<b>Topic</b>	Bentayga - Seven Seat - Third Row Safety Belt (RE20/06)
<b>Market area</b>	Bentley: worldwide (2WBE)
<b>Brand</b>	Bentley
<b>Transaction No.</b>	2058805/2
<b>Campaign number</b>	RB48
<b>Note</b>	
<b>Type</b>	Recall Campaign
<b>US code</b>

### Technical background

Figure 2.

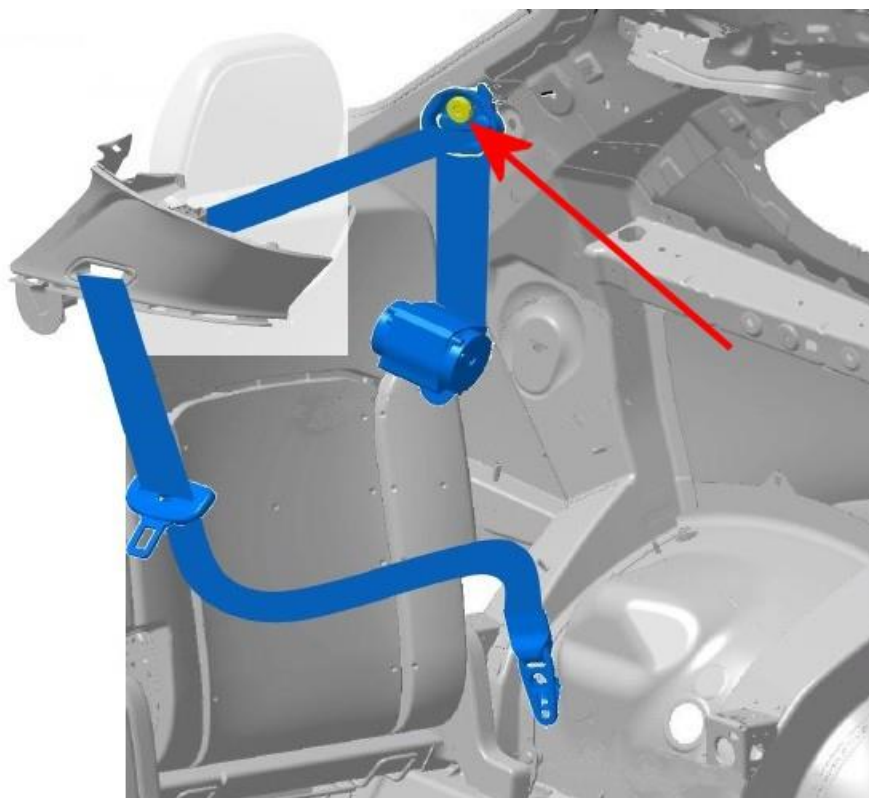
A change to both D-post castings by the Supplier, has resulted in the recess of the threaded hole used to secure the third row safety belt Pillar Loops. This recess reduces the thread engagement with the current securing bolt – N.989.243.03 – away from design intent.

Remove the Socket Head Bolt securing the Pillar Loop to the D-post, discard the Socket Head Bolt and Retaining clip – figure 2.

Fit new Socket Head Bolt - N.912.382.01 – and new Retaining clip – 36A.853.390, torque tighten the Socket Head Bolt to 40Nm.
